# TECHNICAL BULLETIN

## FUEL CELL BAFFLE MODIFICATION

600N helicopters, serial number RN003 thru RN062.

Fuel Cell (P/N 600N8101-5), Fuel Cell (P/N 600N8101-7)

**Figure 1. Fuel Cell Baffle Modification**

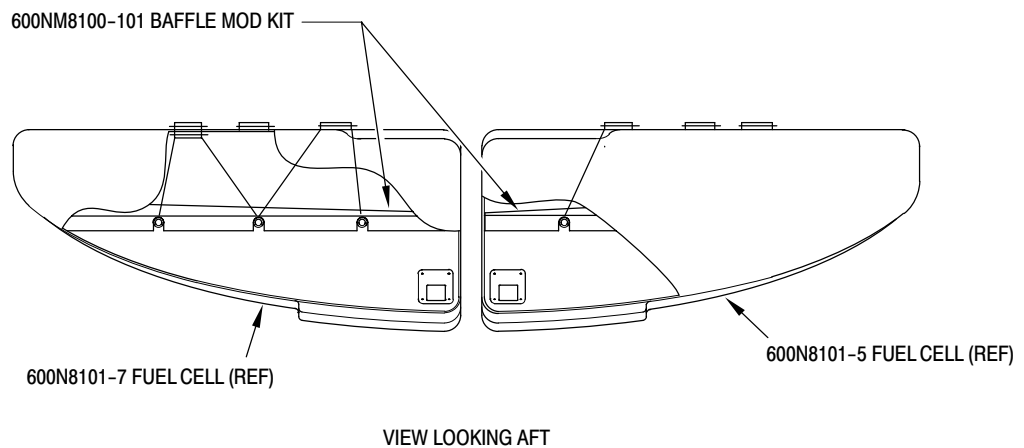
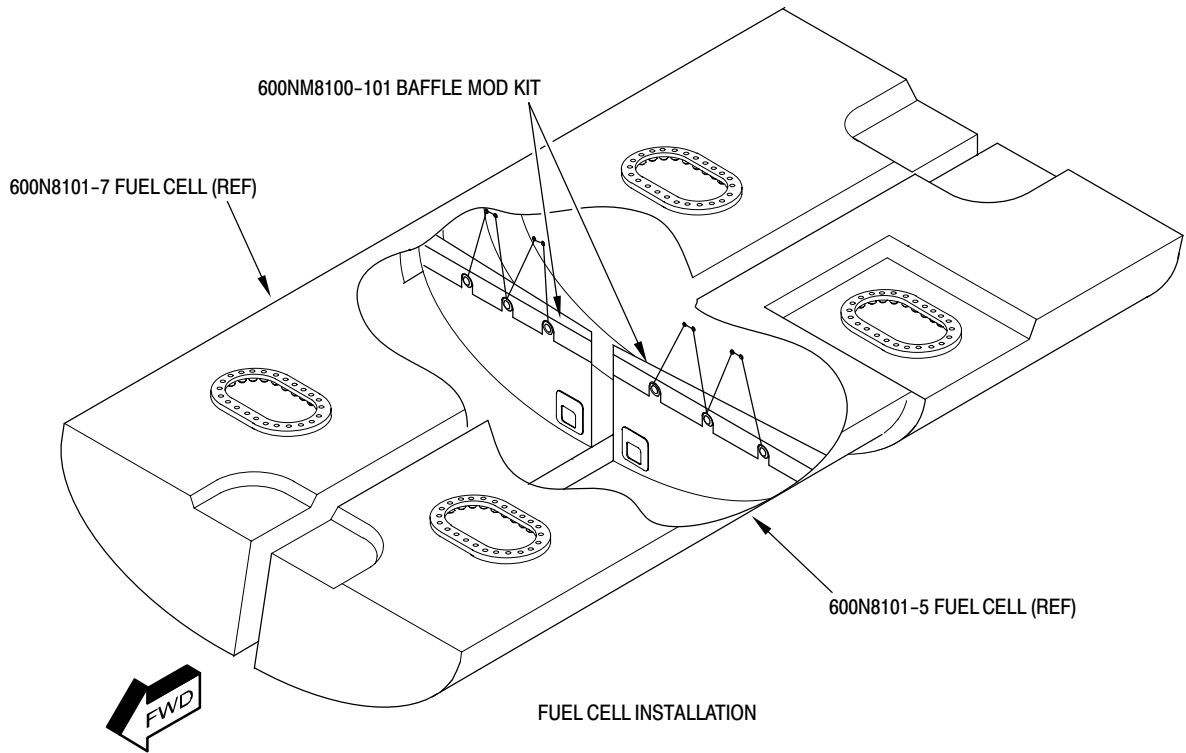
The height of the fuel cell baffle is not sufficient to keep the low fuel sensor submerged during partial power, high-speed descent.

Complying with this Bulletin will reduce the possibility of early/false low fuel warnings during partial power, high-speed descent.

Procedures in this Bulletin provide owners and operators with information pertaining to modification of each fuel cell to extend the height of the baffle.

(Ref. Figure 1)

- (1). Remove cell suspension cords.
- (2). Thoroughly dry wipe interior of cell. Drying time may be accelerated by keeping cell at 80°F (27°C) and ventilating interior with dry, low pressure air.

- (4). Thoroughly wash the baffle and the adjacent fuel tank walls with solvent to ensure oil and/or fuel is removed before beginning rework.
- (5). Using abrasive cloth, buff the faying surfaces of the fuel cell baffle, fuel cell wall and baffle extension.
- (6). Wash buffed area of fuel cell baffle and extension with solvent and allow to dry for a minimum of 20 minutes.

- (8). Apply a thin uniform coat of cement to buffed areas of fuel cell baffle and extension.

- (9). Position extension in place and press firmly in contact areas.
- (10). Work out any bubbles that may be trapped between fuel cell, baffle and extension.

- (11). Apply previously fabricated clamping tool or tongue depressors with clamps to lightly hold extension in place.
- (12). Allow reworked area to dry a minimum of six hours.
- (13). Use solvent to clean any residue after cement has thoroughly dried.
- (14). Install cell suspension cords (CSP-HMI-2, Section 28-00-60, Fuel Cell Installation).
